Brookline Preservation Commission Local Historic District Report

Local Historic District: Cottage Farm

Address: 29 Powell Street

Existing

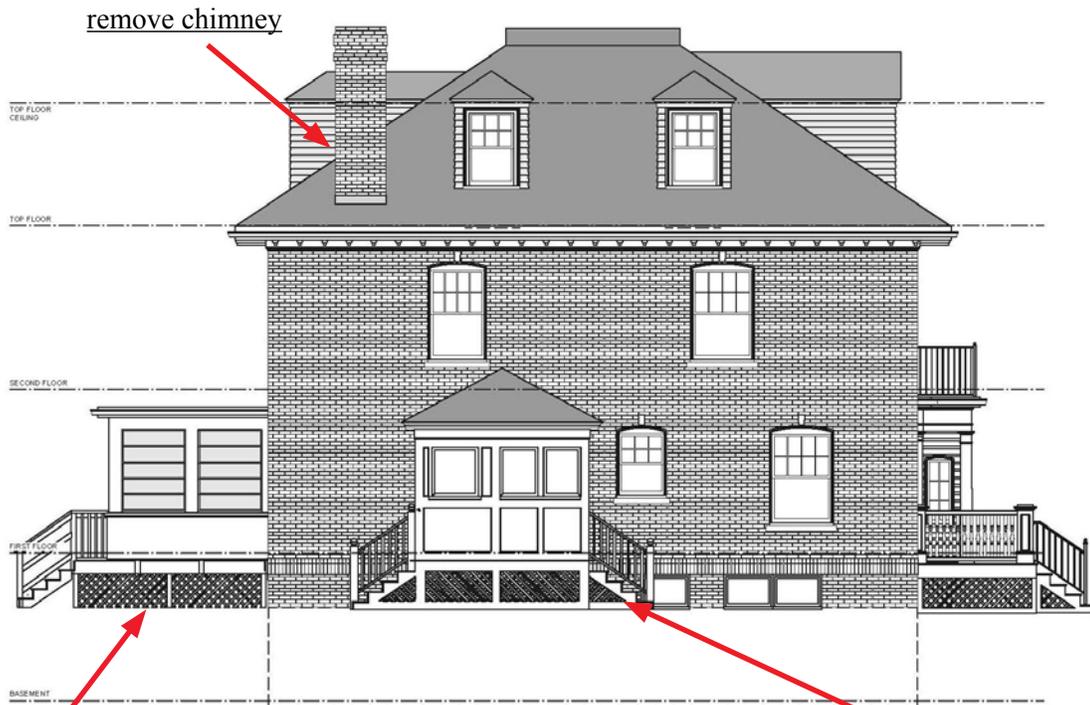
remove chimney

remove door & copy side detail

remove enclosure at entrance

Existing

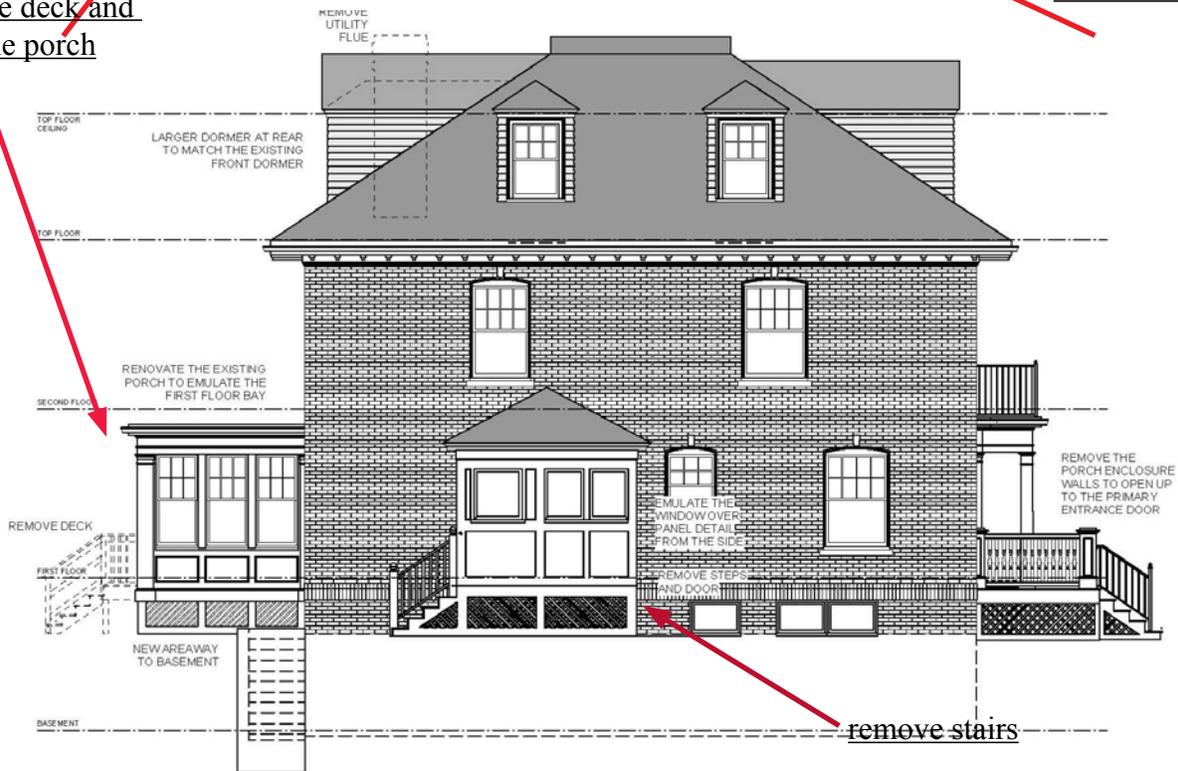
remove deck

remove chimney

remove deck and reframe porch

Proposed south facade

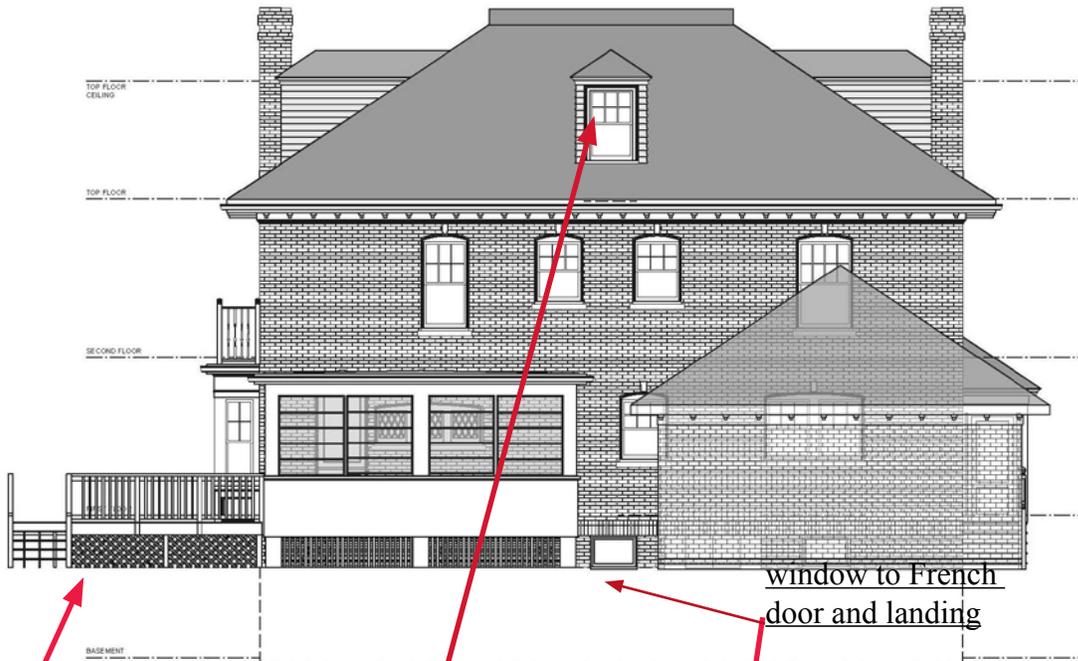
The two issues that are inconsistent with the guidelines are the removal of the clapboarding and windows at the front entrance and the proposed change of the windows on the south facade from an upper diamond pattern over one to a 4 over 1 which matches the oriel windows. The BPC has approved of removal of chimneys that are not the primary ones. (The primary chimney will be rebuilt in kind.) The enlargement of the rear dormer is not inconsistent with the guidelines.

remove stairs

remove stairs

Existing rear elevation

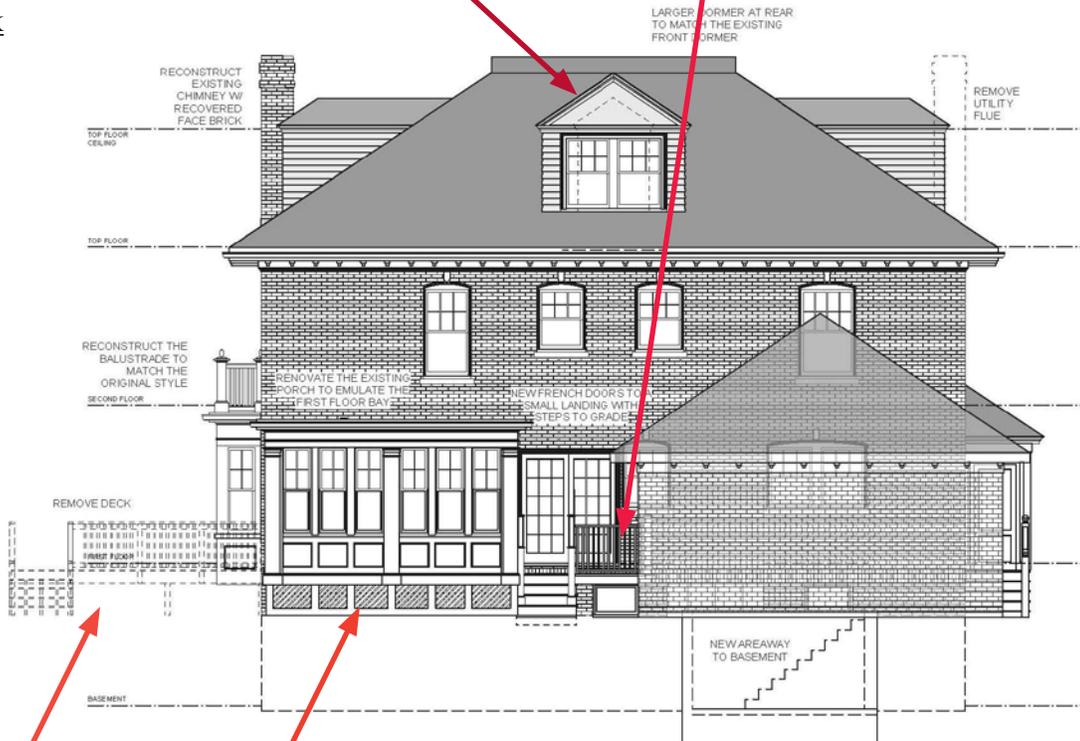
window to French door and landing

enlarge dormer

remove deck

REAR ELEVATION
1/8" = 1'-0"

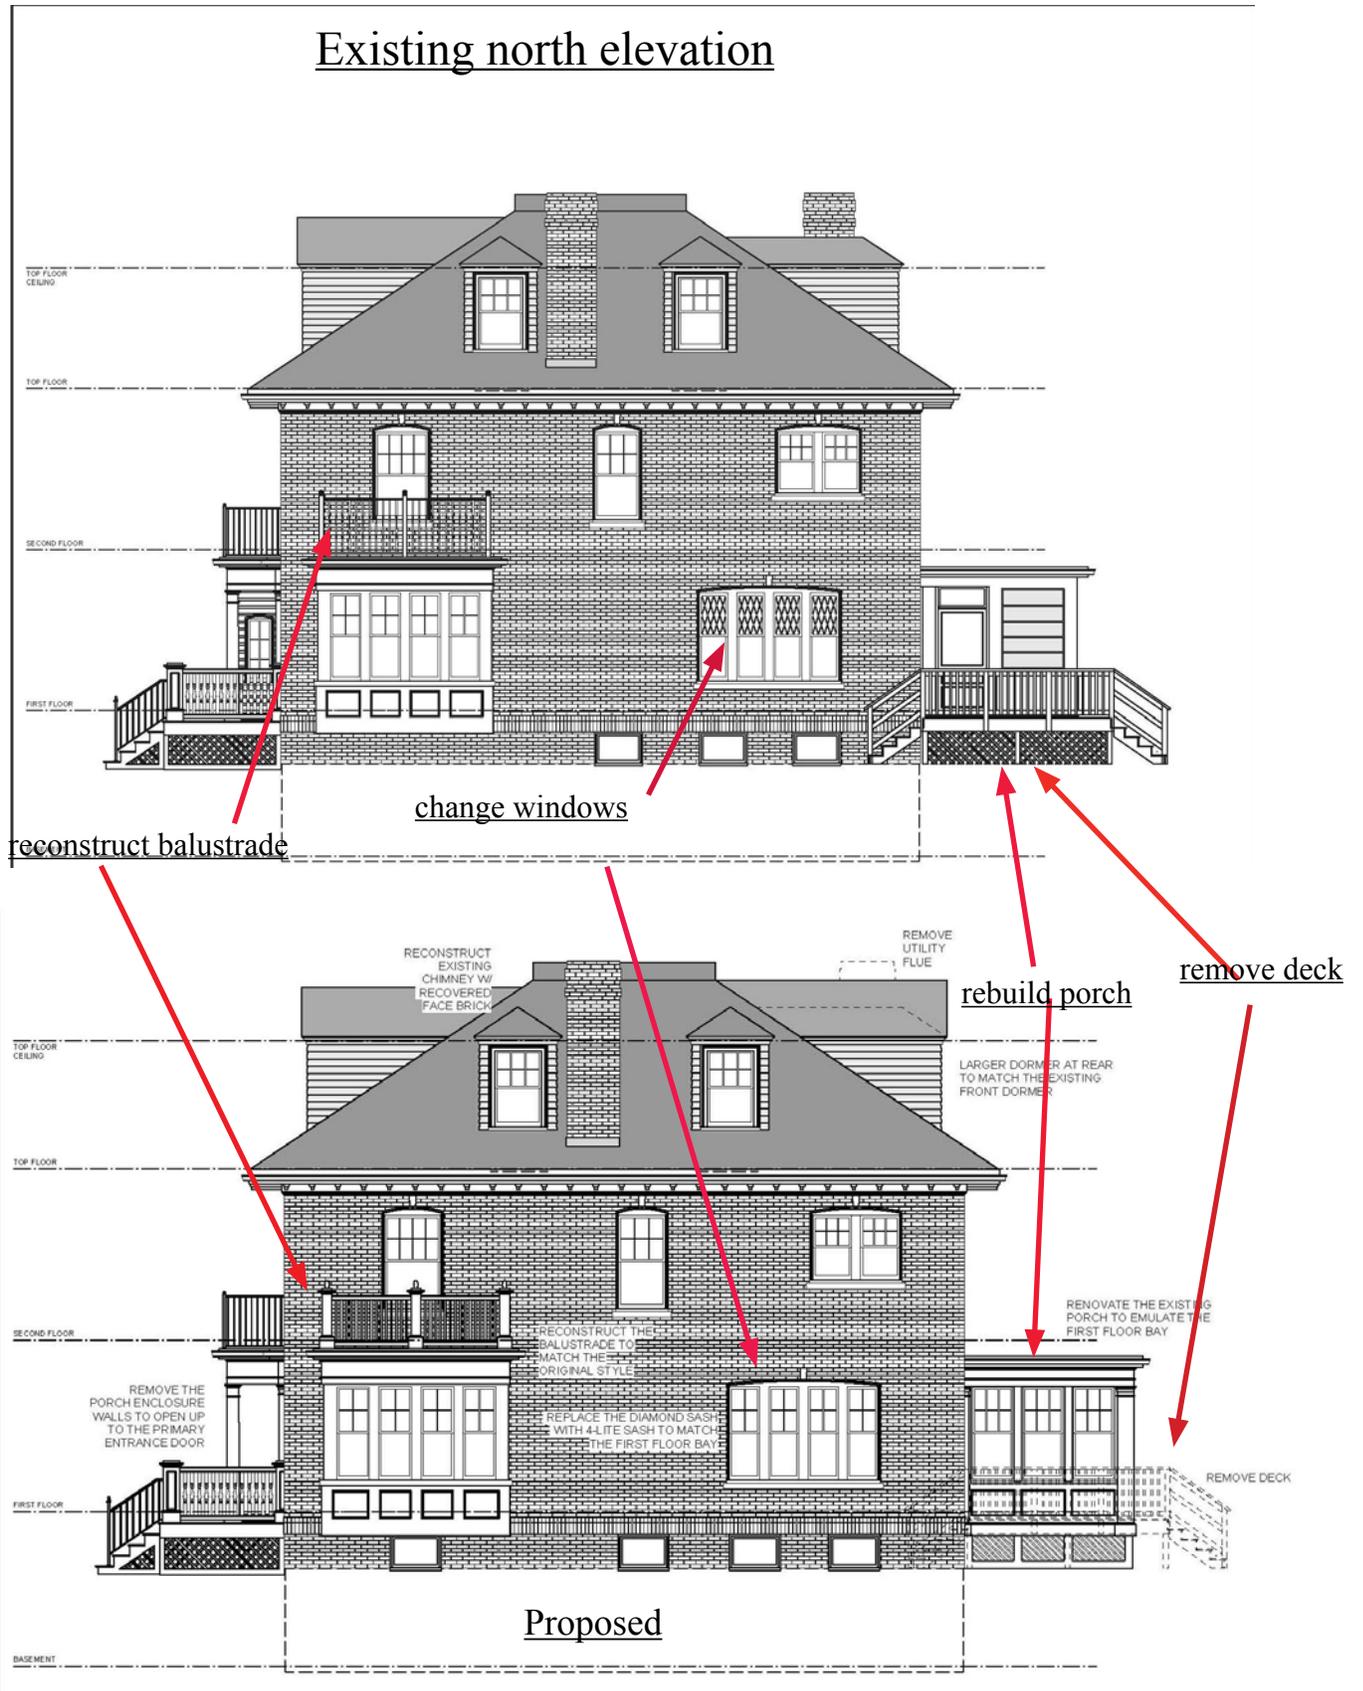
LARGER DORMER AT REAR TO MATCH THE EXISTING FRONT DORMER

REMOVE UTILITY FLUE

RECONSTRUCT EXISTING CHIMNEY W/ RECOVERED FACE BRICK

RECONSTRUCT THE BALUSTRADE TO MATCH THE ORIGINAL STYLE

RENOVATE THE EXISTING PORCH TO EMULATE THE FIRST FLOOR BAY

NEW FRENCH DOORS TO SMALL LANDING WITH STEPS TO GRADE

REMOVE DECK

NEW AREAWAY TO BASEMENT

remove deck

rebuild porch

Existing

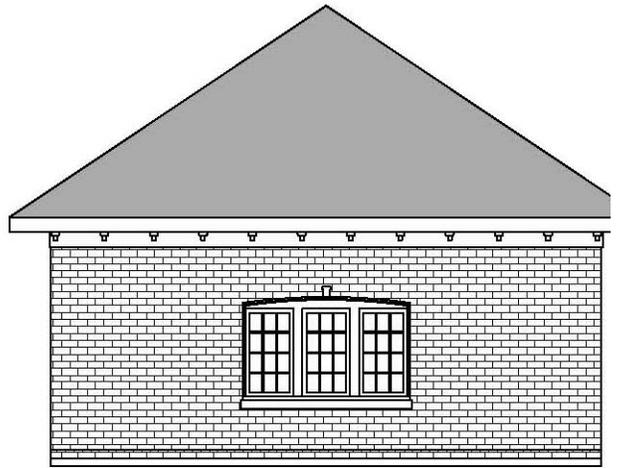
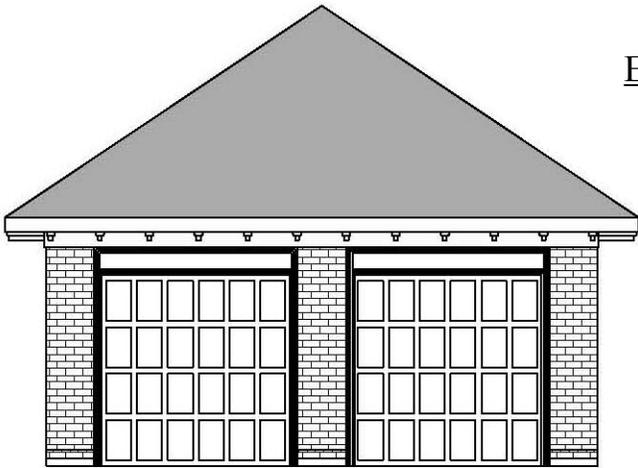
Preliminary Findings: The rear deck and enclosed porch are not original and are minimally visible from Amory Street.. The reconstruction of the balustrade over the oriel is shown in the 1912 *American Architect* photo. Several of the original windows were removed and replaced with non-approved ones- the applicant proposed to replace the non-conforming ones with single pane true divided windows as well as the originals for consistency. The change to the side entrance, removing steps and door, is not incongruous with the design. The proposed new fenestration of the enclosed rear porch is appropriate and minimally visible, as are the addition of the rear door and landing. The new garage doors are not inconsistent and appear as two doors.

change garage doors

BY SINGLE 16' GARAGE
DOOR TO REPLACE THE 2
ORIGINAL DOORS

TOOTH IN MATCHING
BRICK EACH SIDE AS
REQUIRED
